# DK Global Fashion Wear Ltd.

17 July 2023

## Structural Inspection Report

Observations & Actions

# Lack of lateral stability system

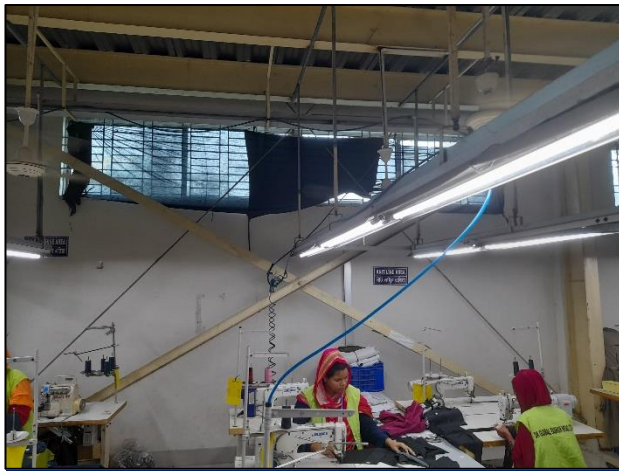
Compression strut missing in gable frame

Roof and wall bracing were provided at some location. However, compression strut was missing in gable frames to transfer the lateral load therefore lateral stability system of the shed is apparently incomplete. Building engineer is required to check the lateral stability system of the structure and suggest necessary remedial actions accordingly.

- Building engineer is required to check the lateral stability of the structure and suggest necessary remedial actions accordingly.

- Implement remediation work where required.

# Lack of information in as-built drawing

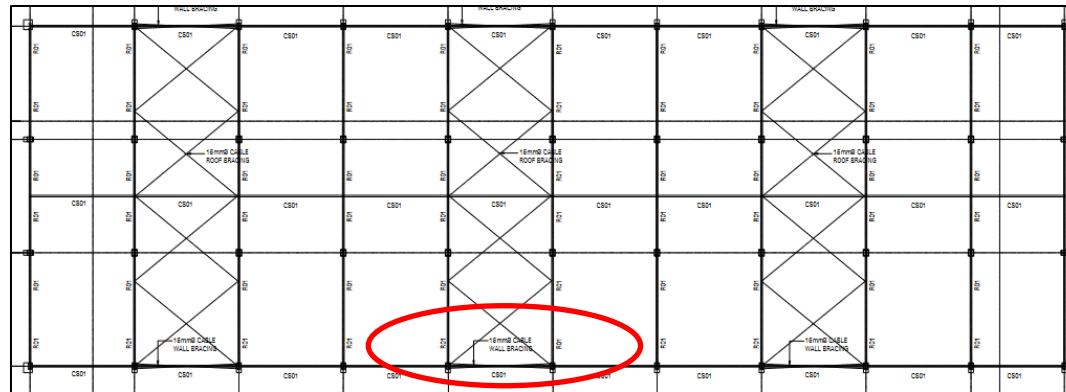
In bracing layout plan, only horizontal and vertical cable bracing was shown. However, no information was available regarding vertical angle bracing on ground floor. In addition, elevation view and connection details of bracings were also not present in the as-built structural drawing. The building engineer is required to survey the whole structures and prepare accurate as-built drawings accordingly.

- The building engineer is required to survey the structure and prepare accurate as-built drawing.

**Significant gap in connection at several location**

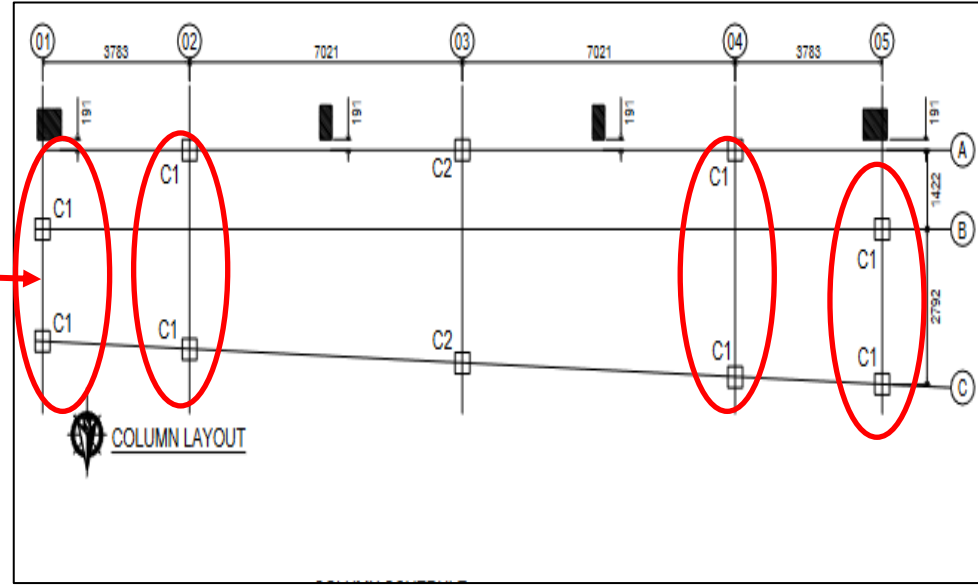
Significant gap in steel connection plates in different location

Significant gap in steel connection plates of rafter & column was found at different locations of the structure. Building engineer is required to survey the whole structure & identify the locations of the connection gaps. Factory engineer is also required to assess the reason of connection gap & provide proper remediation. Factory is required to follow recommendation of remediation suggested by the engineer.

- Building engineer is required to repair the gap in connections with a suitable method.
